# An Assessment of Santee Cooper's 2008 Resource Planning

David Schlissel, Rachel Wilson, Lucy Johnston and Dr. David White

April 22, 2009

Figure 2. Emissions of CO<sub>2</sub> in 2007 and 2024 in EGEAS scenarios modeled by Santee Cooper.<sup>14</sup>

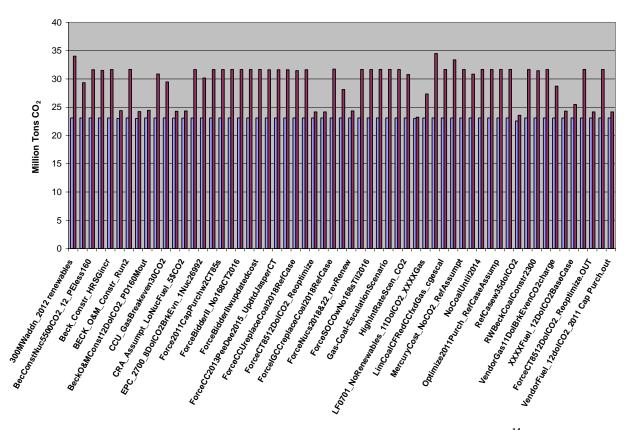
The evidence for this conclusion is found in the results of the EGEAS resource planning model used by Santee Cooper. EGEAS reports the annual CO<sub>2</sub> emissions for each generating resource in the output files for each scenario examined. As shown in Figure 2 below, Santee Cooper's annual CO<sub>2</sub> emissions would increase between 2007 and 2024 in each of the EGEAS scenarios

that Santee Cooper provided to Synapse. In some scenarios, these increases are rather dramatic (as high as 30 percent) due to the addition of both Pee Dee River units. In other scenarios, Santee Cooper's annual CO<sub>2</sub> emissions would be only slightly higher in 2024 than they were in 2007 – reflecting the building of either no new coal plants or only one of the Pee Dee River units and the addition of ownership interests in two nuclear units. In none of the scenarios modeled by Santee Cooper do its annual CO<sub>2</sub> emissions decline from 2007 through 2024.

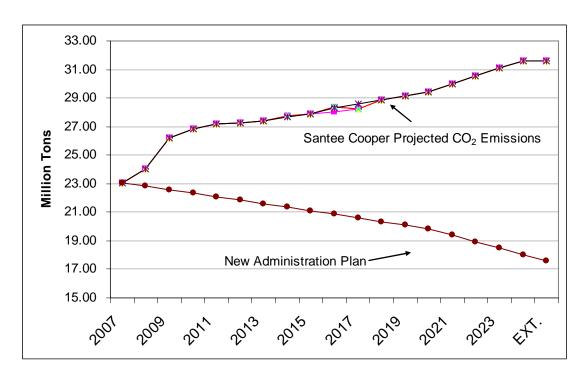
Figure 3, below, provides an illustrative example of Santee Cooper's future annual CO<sub>2</sub> emissions in one of the scenarios that includes construction of both Pee Dee River units and compares that trajectory to the emissions reductions that would be required under the Obama Administration's recently announced cap-and-trade system.

As can be seen, adding either one or both of the Pee Dee River coal plants would be inconsistent with national emissions trends under evolving federal climate change policies. Even in those scenarios in which only one Pee Dee River unit is built, Santee Cooper's CO<sub>2</sub> emissions would increase between 2007 and 2024, counter to the national CO<sub>2</sub> emission trends that would be mandated under plans being considered by the Obama Administration and Congress. Building both Pee Dee River units would certainly be a major step in the wrong direction. Santee Cooper should be examining plans and options for reducing, not increasing, its greenhouse gas emissions by building the Pee Dee River coal-fired power plants.

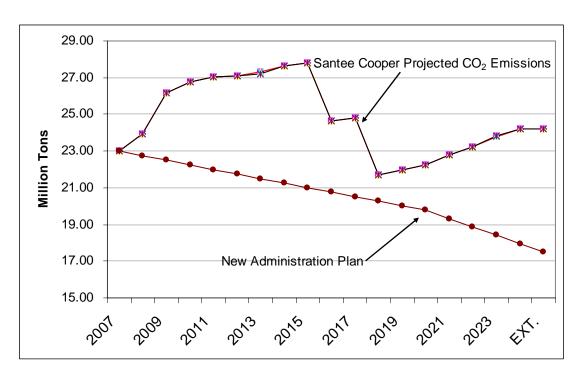
Figure 4, below, provides an example of Santee Cooper's annual CO<sub>2</sub> emissions in a scenario in which only Pee Dee River Unit 1 is built and where ownership interests in two nuclear units are added in place of Pee Dee River Unit 2. Santee Cooper's annual CO<sub>2</sub> emissions in this scenario would continue to be significant higher in 2020 and 2024 than federally mandated emissions levels and the gap would appear to be growing.

Figure 6. CO<sub>2</sub> prices used by Synapse and Santee Cooper vs. results of modeling analyses of major bills in the 110th U.S. Congress – levelized CO<sub>2</sub> prices (2013-2030, in 2007 dollars).

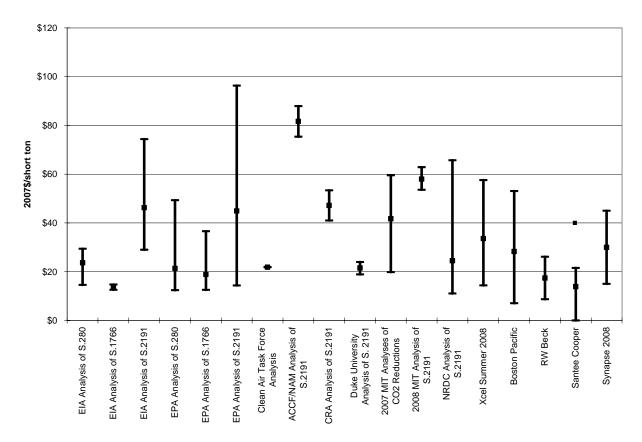
Figure 6 also presents the range of CO<sub>2</sub> prices used by Santee Cooper in its 2008 resource planning analyses. Clearly, except for a single sensitivity scenario, this range of CO<sub>2</sub> prices was

very low compared to the full range of CO<sub>2</sub> emissions allowance prices that could result from adoption of the major greenhouse gas regulatory proposals that are being considered by the federal government. In fact, there are a significant number of possible scenarios where CO<sub>2</sub> emissions allowance prices could be substantially higher than the high ends of the price ranges that Santee Cooper used in its resource planning analyses. Because coal is the most carbon intensive fuel, these low CO<sub>2</sub> prices distorted and biased the analyses in favor of new coal plants. As can be seen from Figure 6, the range of CO<sub>2</sub> prices that R.W. Beck recommended that Santee Cooper use in its resource planning also is very low compared to the full range of possible prices that could result from the adoption of the major proposals for greenhouse gas regulation that have been announced by the Administration or that are being considered in Congress.

Figure 9. The relationship between CO<sub>2</sub> emissions allowance prices and natural gas prices.

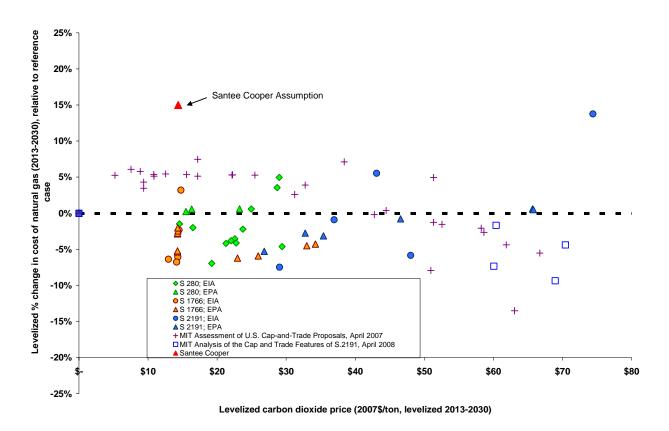
As shown clearly in Figure 9, Santee Cooper has assumed that there would be a very significant increase in the levelized price of natural gas at a relatively low levelized CO<sub>2</sub> price. This assumption is not supported by the results of the independent modeling analyses of carbon dioxide regulation. Instead, as can be seen from Figure 9, in all but one of the scenarios studied, federal regulation of greenhouse gas emissions would have a much smaller impact on natural gas prices than Santee Cooper has assumed – and that single scenario featured a levelized CO<sub>2</sub> price of approximately \$75/ton, a far higher price than Santee Cooper has assumed in its planning analyses. In fact, in some scenarios, the models forecast that the adoption of greenhouse gas regulation might lead to lower natural gas prices as natural gas usage and demand declined due to its greenhouse gas emissions. Thus, there is no evidence to support Santee Cooper's assumption in its 2008 resource planning analyses that federal regulation of greenhouse gas emissions would inevitably lead to substantial increases in the price of natural gas, particularly at relatively low CO<sub>2</sub> prices.
